Groundwater Application Review Summary Form

Application # G- 18833	
GW Reviewer M. Proma	Date Review Completed: 08-22-19
Summary of GW Availability and Injury Review:	
Groundwater for the proposed use is either of amounts requested without injury to prior water capacity of the groundwater resource per Section	
Summary of Potential for Substantial Interferen	nce Review:
[] There is the potential for substantial interference	ence per Section C of the attached review form.
Summary of Well Construction Assessment:	
[] The well does not appear to meet current we review form. Route through Well Construction a struction of the structure.	Il construction standards per Section D of the attached and Compliance Section.
This is only a summary. Documentation is attach	ned and should be read thoroughly to understand the

Review of Water Right Application G-18833

TO:			Rights Se						Date		08/22/20	019		
FROM	:	Groun	ndwater Se	ction		M Thon								
SUBJE	CT:	Appli	cation G- <u>1</u>	8833			wer's Nam ersedes		iew of		, D	ate of Revi	ew(s)	
PURLI	C INTE	REST	PRESIIN	APTION;	GROUND	WATER	,							
								lwate	er use will er	isure th	e nreser	vation of	the nubli	ic
welfare,	safety an	d heali	h a

Water-Level Trends in Nearby Wells

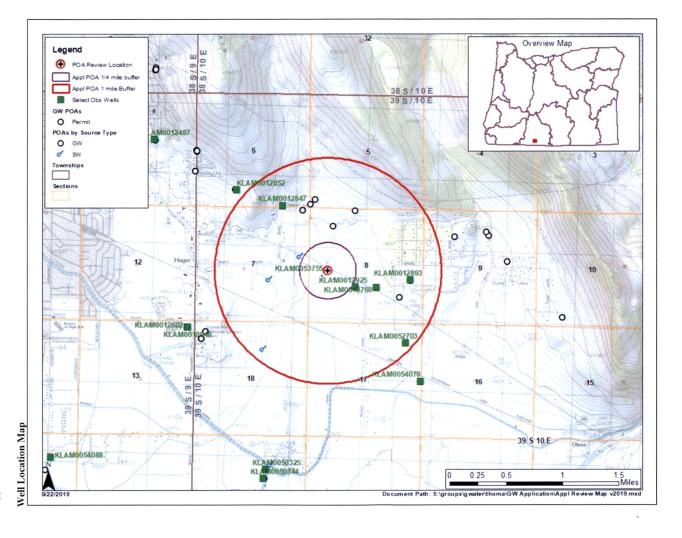
a. b. c. d. b. c.	 is over appropriated, ☐ is not over appropriated, or ☐ cannot be determined to be over appropriated during any period of the proposed use. * This finding is limited to the groundwater portion of the over-appropriation determination as prescribed in OAR 690-310-130; index will not or ☐ will likely be available in the amounts requested without injury to prior water rights. * This finding is limited to the groundwater portion of the injury determination as prescribed in OAR 690-310-130; index will not or ☐ will likely to be available within the capacity of the groundwater resource; or ☐ will, if properly conditioned, avoid injury to existing groundwater rights or to the groundwater resource:
